# City of San Diego

## **BOTANICAL BUILDING IMPROVEMENTS**

RFQ NO.: **K-20-1932-DB2-3**

RFP NO.: **K-21-1932-DB2-3-A**

## BOTANICAL BUILDING EAST DEMOLITION PLAN

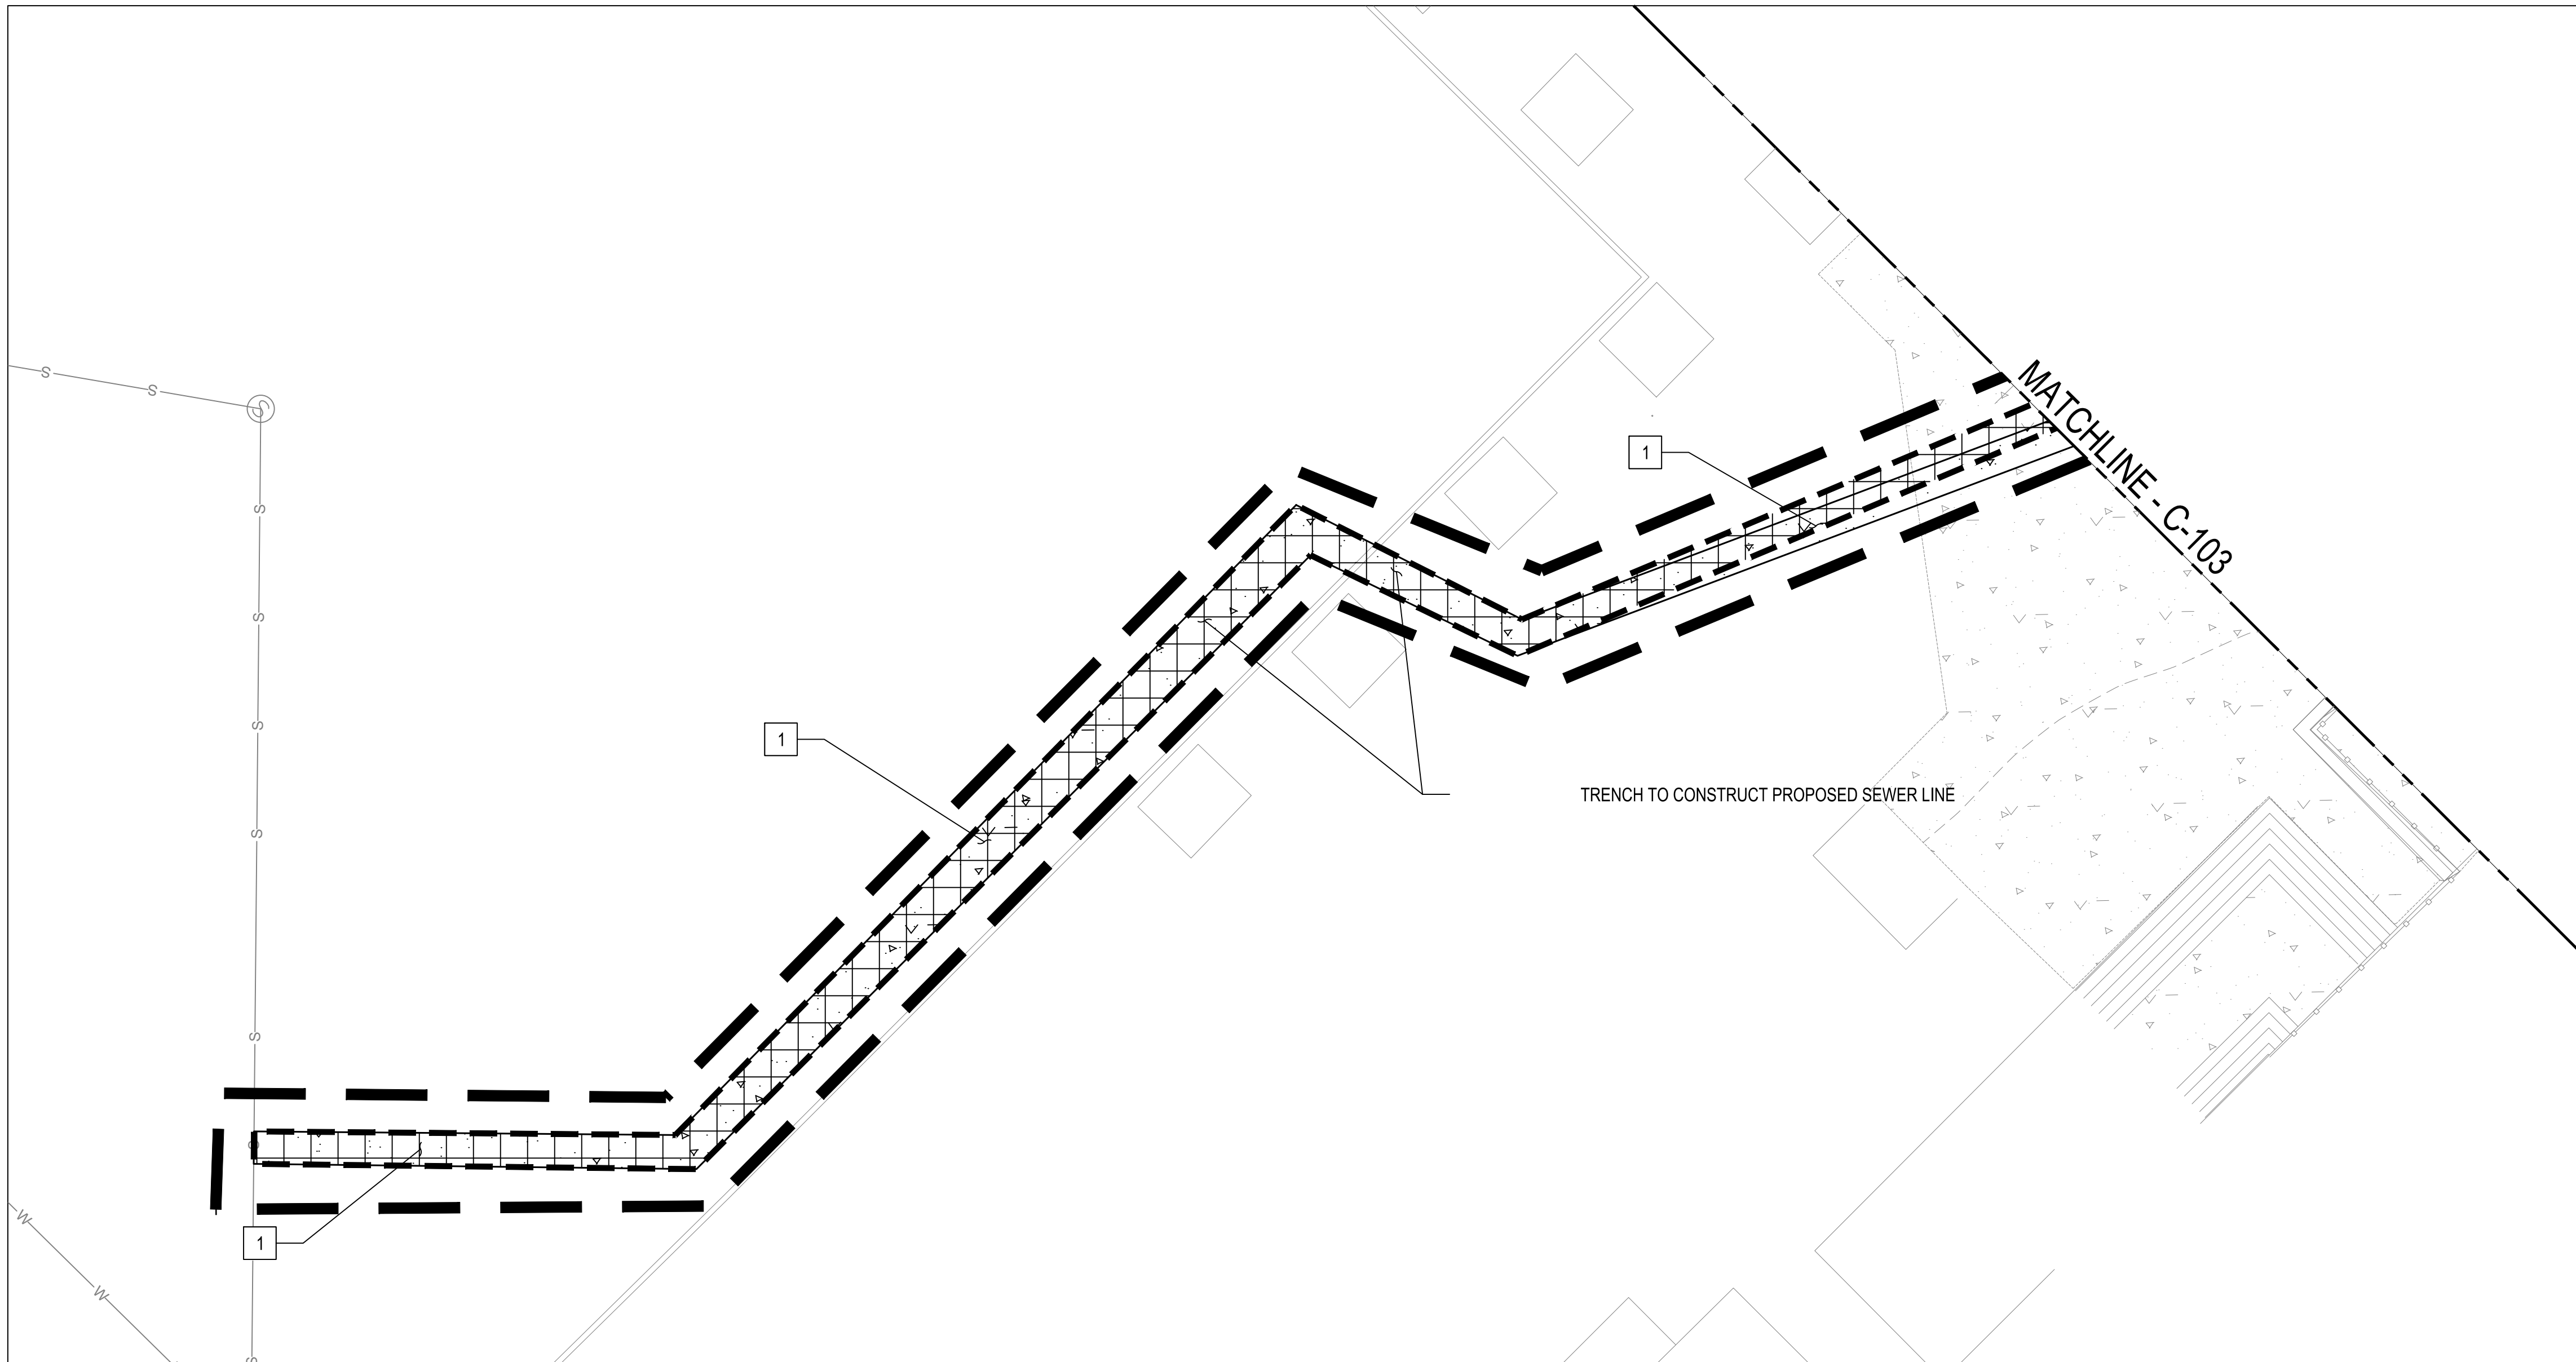
1. To Civil Sheets, C-101 through C105 and C-202, **DELETE** in their entirety and **REPLACE** with pages 27 through 32 of this Addendum.
2. To Landscape Sheets, L1.02-L1.06, **DELETE** in their entirety and **REPLACE** with pages 33 through 37 of this Addendum.

**L1.03**

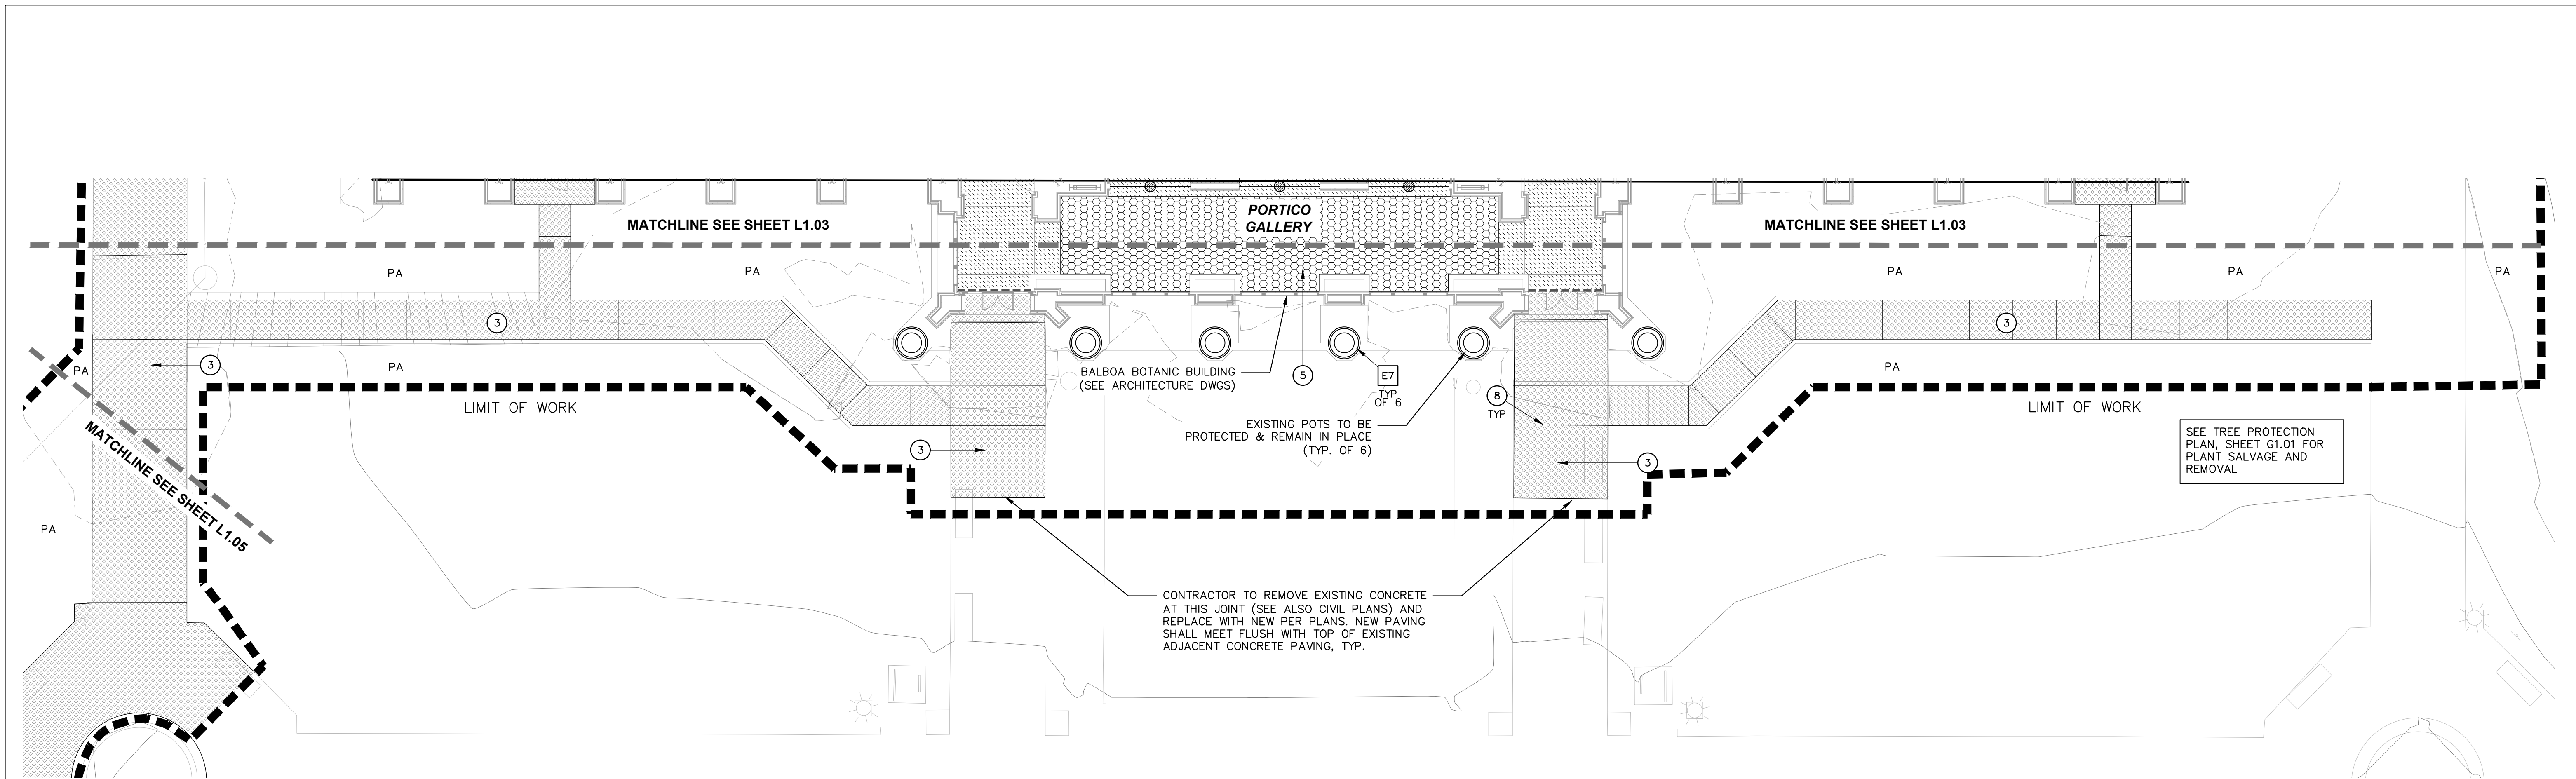
Q15. Notes 17 and 18 on Sheet L1.03 indicates to connect new trench drain and area drain to sewer line. These drains will collect rain water and potentially irrigation water as this portion of the building is not weatherproof. Please clarify if the City has determined that the rain water and/or irrigation water can be conveyed to the sewer system or if it should be connected to the storm drain system and properly treated. This could potentially have an impact on the size of storm water treatment system per City Standards 2.1.22.4.5 (Exterior Irrigation) – “There

A15. DB to assess existing condition of vitrified clay pipe (refer to As-Built 5\_5\_Botanical Building\_12191\_Set), clean and flush before pipe connection. Refer to revised sheet L1.03 for more details.
